Z O N I N G A D J U S T M E N T S B O A R D S T A F F R E P O R T

FOR BOARD DISCUSSION
NOVEMBER 8, 2017

600 ADDISON STREET

Project Preview and Draft EIR Scoping Session for Master Use Permit #ZP2015-0238 to demolish buildings and structures on an industrial site of approximately 8.67 acres, and to construct a research and development campus containing several multiple-story buildings totaling 475,000 square feet of gross floor area and including 830 on-site parking spaces.

Figure 1: Conceptual Site Plan for Proposed Development Scheme 1

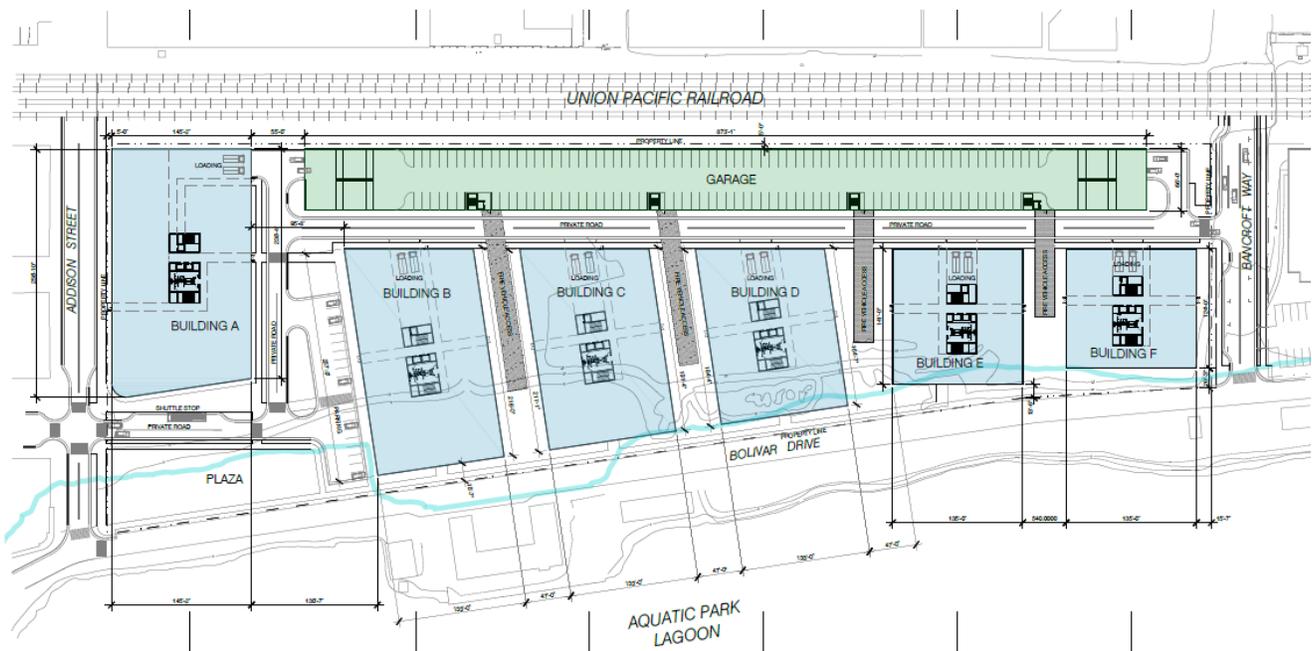
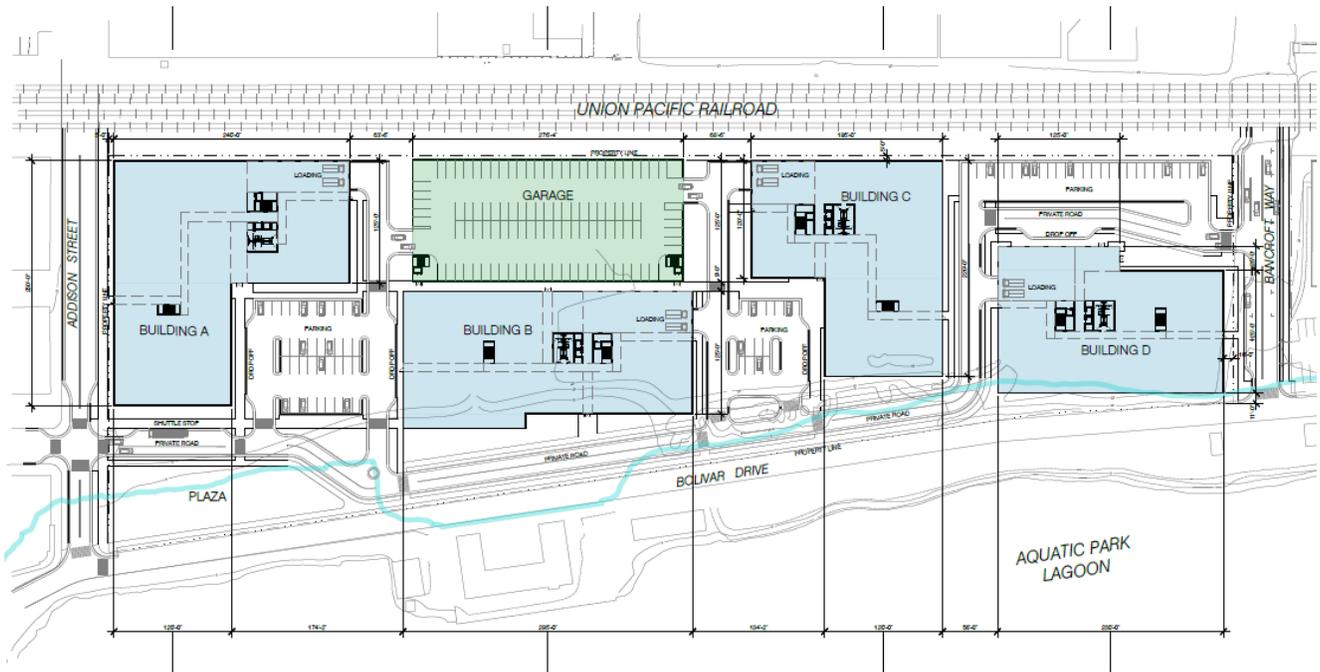
Multiple development proposal schemes. The applicant presents two development schemes for the City's consideration. Both scenarios would meet the MU-LI zoning

district provisions for development, but each may have its own specific merits and favorable aspects. Therefore, the Board should comment on these schemes separately as well as comparatively in the preview discussion.
